SUBJECT: R.E. GINNA NUCLEAR POWER PLANT - STAFF ASSESSMENT OF INFORMATION PROVIDED PURSUANT TO TITLE 10 OF THE *CODE OF FEDERAL REGULATIONS* PART 50, SECTION 50.54(f), SEISMIC HAZARD REEVALUATIONS FOR RECOMMENDATION 2.1 OF THE NEAR-TERM TASK FORCE REVIEW OF INSIGHTS FROM THE FUKUSHIMA DAI-ICHI ACCIDENT (TAC NO. MF3972)

Enclosure:  
Staff Assessment of Seismic  
Hazard Evaluation and Screening Report

R.E. GINNA NUCLEAR POWER PLANT

Figure 3.3-1 Plot of Staff's and Licensee's Base Case Shear-Wave Velocity Profiles for the Ginna site

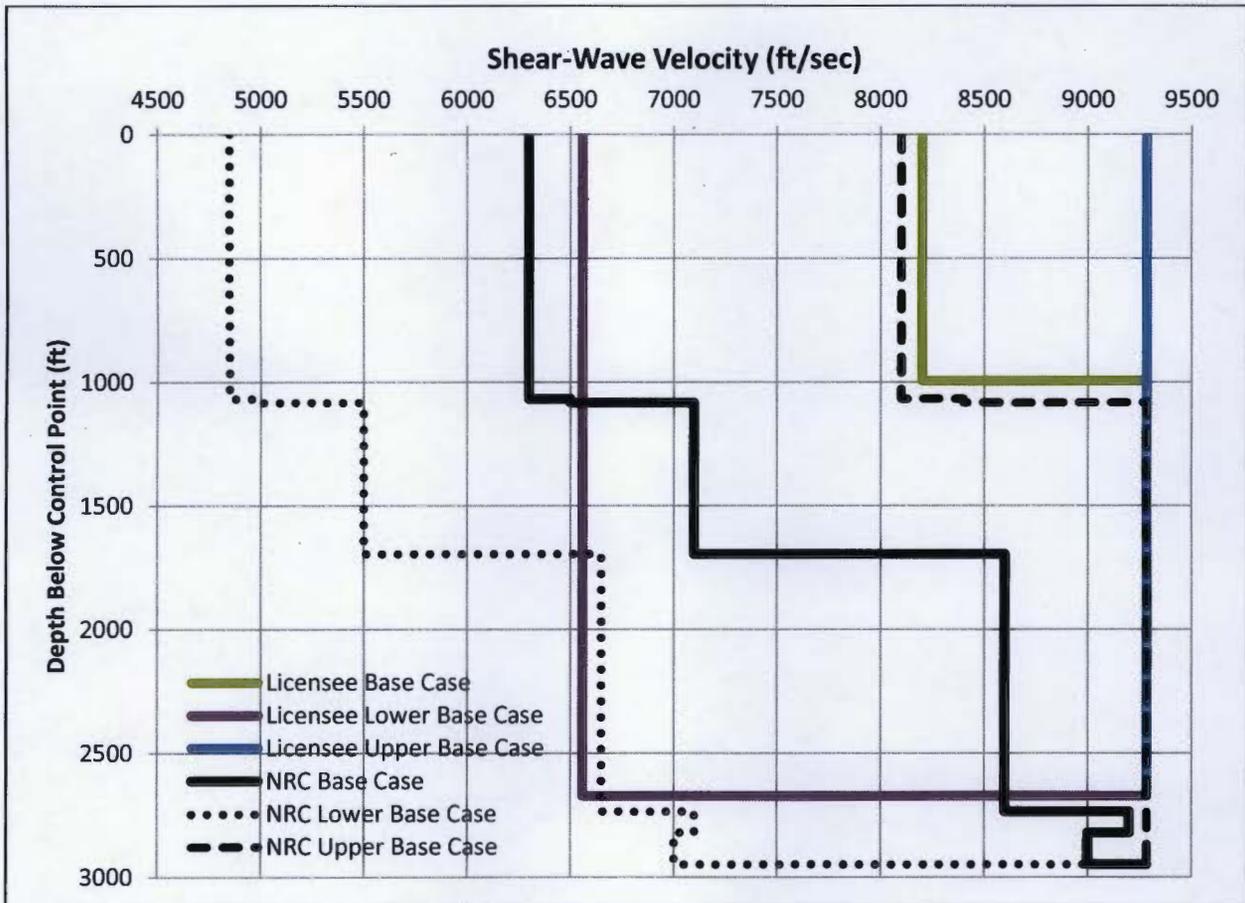
To characterize the subsurface geology, the licensee developed three site base case profiles. The middle, or best estimate, profile was developed using measured and assumed compressional wave velocities and assumed Poisson's ratios (a ratio of the compressional wave to shear wave velocity). The licensee developed upper and lower base case profiles using a natural log standard deviation of 0.2 and limited the upper base case velocity to 9,285 ft/s (2,800

m/s), the velocity of hard rock. Figure 3.3-1 of this assessment shows the licensee's three shear-wave velocity base case profiles.

Because many of the same geologic units underlie both the Ginna and the Nine Mile Point sites, the staff used geophysical measurements from the Nine Mile Point, Unit 3 SAR for these common geologic units. The staff used these velocity data along with information about the thickness of geologic units from deep well data to develop the middle, or best estimate, base case velocity profile. Geologic evidence at the nearby borehole indicated approximately 2950 ft of sedimentary rock overlying the Precambrian basement (Kreidler et al., 1973). Because the site lacks specific data about layer thicknesses and seismic velocities, the staff used Appendix B of the SPID to generate upper and lower base case profiles using a natural log standard deviation of 0.2. To capture the uncertainty in the depth to base rock, the staff used a value of  $\pm 150$  ft ( $\pm 46$  m), which is consistent with the more recent investigations for Nine Mile Point and considerably less than the  $\pm 802$  ft ( $\pm 245$  m) depth used by the licensee. Figure 3.3-1 of this assessment shows the velocity profiles developed by the staff compared with those developed by the licensee. Estimates of shear-wave velocity and profile thickness determined by the staff differ somewhat from those developed by the licensee. However, as described below, these differences do not significantly impact the final hazard results.

Figure 3.3-2 Plot Comparing the Staff's and the License's Median Amplification Functions and Uncertainties for the Ginna site

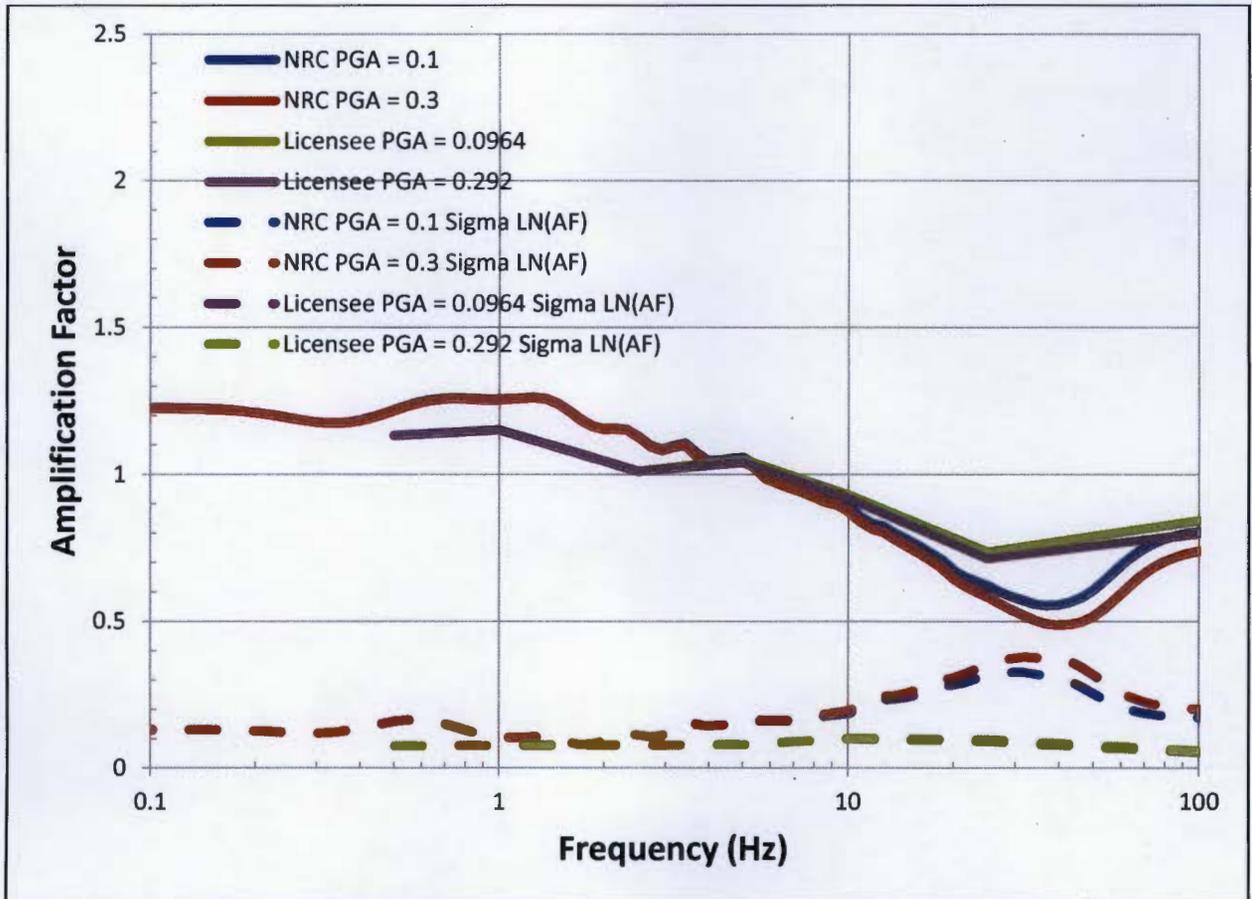
To determine the value of kappa, the staff used the low strain damping values, shear wave velocities, and layer thicknesses for each layer to arrive at values of 0.016, 0.018, and 0.009 sec for the best-estimate, lower, and upper velocity profiles, respectively. These three kappa values include the 0.006 sec contribution from the hard rock. To further model the uncertainty in the kappa value, the staff used a natural log standard deviation of 0.35 to calculate lower and upper values of kappa for each profile. This approach resulted in nine kappa values, which range from 0.006 to 0.029 sec. The staff applied this approach to account for the large uncertainties

associated with estimating kappa for the Ginna site, for which limited subsurface data were collected. The staff gave the best-estimate kappa values for each profile a weight of 40 percent and the upper and lower kappa values a weight of 30 percent each in the site response analysis. Figure 3.3-2 of this assessment shows a comparison of the staff's and the licensee's median site amplification functions and uncertainties ( $\pm 1$  standard deviation) for two of the eleven input loading levels. The NRC staff's and licensee's amplification functions are generally similar in shape and amplitude. Amplification functions determined by the staff are slightly higher than those developed by the licensee for frequencies between 0.2 and 5 Hz. However, as shown in Figure 3.3-3 of this assessment, these differences in site response analysis do not have a large impact on the control point seismic hazard curves, or the resulting GMRS, as discussed below. Appendix B of the SPID provides guidance for performing site response analyses, including capturing the uncertainty for sites with less subsurface data; however, the guidance is neither prescriptive nor comprehensive. As such, various approaches in performing site response analyses, including the modeling of uncertainty, are acceptable for this application.

Figure 3.3-3 Plot Comparing the Staff's and the Licensee's Mean Control Point Hazard Curves at a Variety of Frequencies for the Ginna site

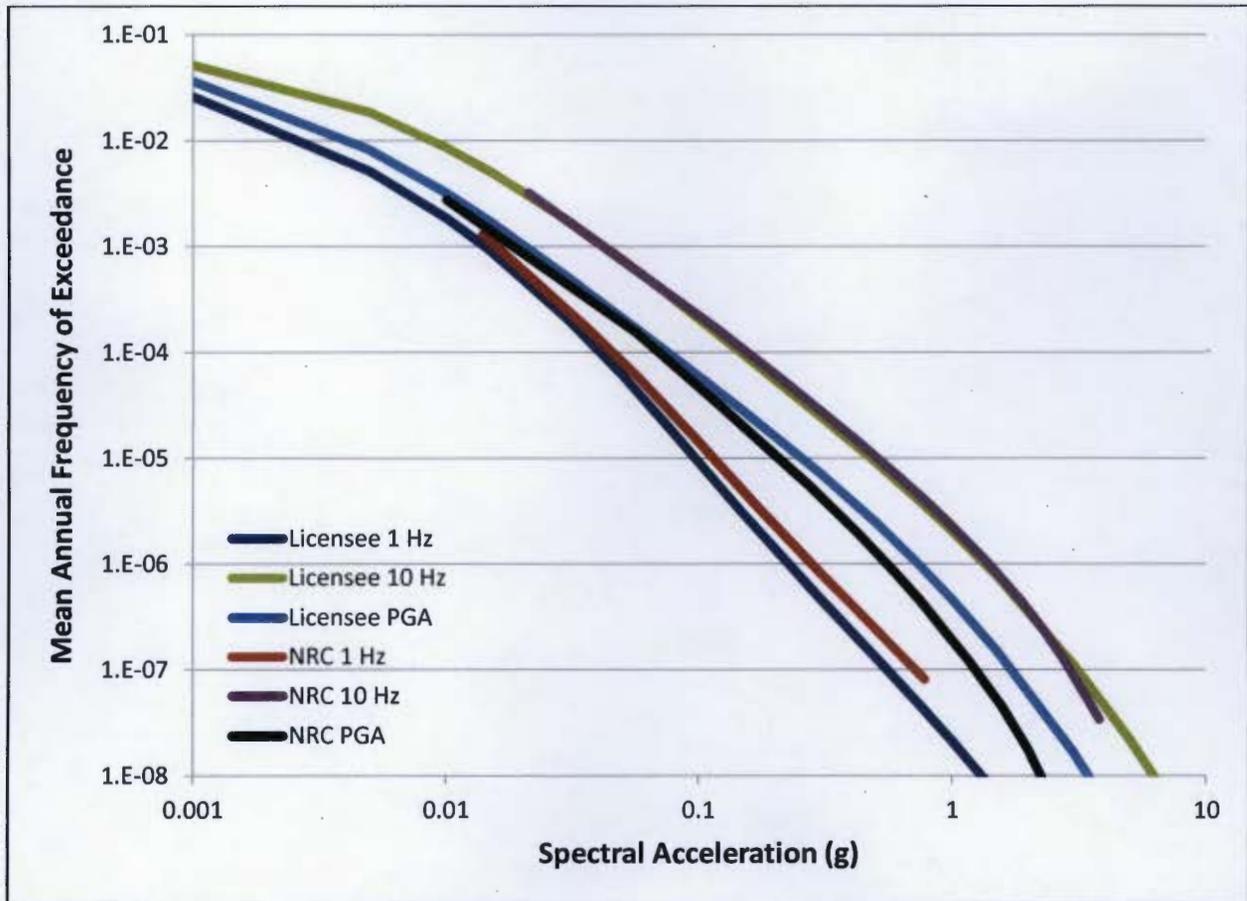
In summary, the staff concludes that the licensee's site response analysis was conducted using present-day guidance and methodology, including the NRC-endorsed SPID. The NRC staff performed independent calculations which confirm that the licensee's amplification factors and control point hazard curves adequately characterize the site response, including the uncertainty associated with the subsurface material properties, for the Ginna site.

Figure 3.4-1 Comparison of the Staff's GMRS with Licensee's GMRS and the Ginna SSE

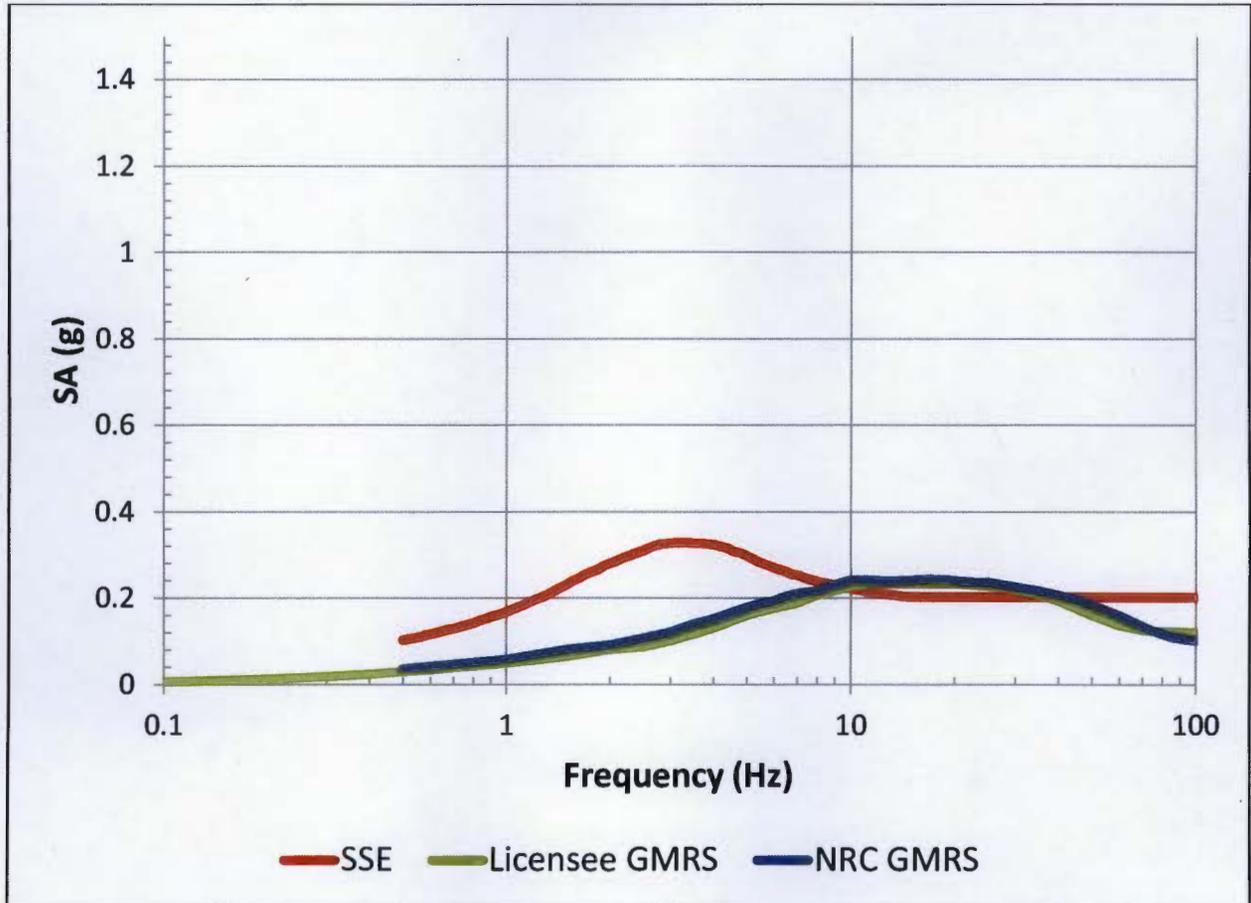
The NRC staff independently calculated  $10^{-4}$  and  $10^{-5}$  UHRS using the results of its confirmatory PSHA and site response calculations described in Sections 3.2 and 3.3 of this staff assessment, respectively. Figure 3.4-1 of this assessment shows a comparison of the GMRS determined by the licensee to that determined by the staff.

As shown in Figures 3.4-1 of this assessment, the NRC staff's GMRS is very similar to the licensee's in both amplitude and shape. The NRC staff confirms that the licensee used the present-day guidance and methodology outlined in RG 1.208 and the SPID to calculate the horizontal GMRS, as requested in the 50.54(f) letter. As such, the NRC staff concludes that the GMRS determined by the licensee adequately characterizes the reevaluated hazard for the Ginna site. Therefore, this GMRS is suitable for use in subsequent evaluations and conformations, as needed, for the response to the 50.54(f) letter. The NRC staff performed both a PSHA and site response confirmatory analysis and achieved results consistent with the licensee's horizontal GMRS.

In reaching this determination, the NRC staff confirmed the licensee's conclusion that the licensee's GMRS for the Ginna site is bounded by the SSE for Ginna in the 1 to 10 Hz range, except for a narrow band exceedance between 9 and 10 Hz. The staff also confirmed the licensee's conclusion that the GMRS exceeds the SSE for Ginna above 10 Hz. As such, a seismic risk evaluation and SFP evaluation are not merited and a high-frequency confirmation is merited in accordance with the SPID criteria. The NRC review and acceptance of Exelon's high-frequency confirmation (i.e., Item (4)) will complete the Seismic Hazard Evaluation identified in Enclosure 1 of the 50.54(f) letter, for Ginna.
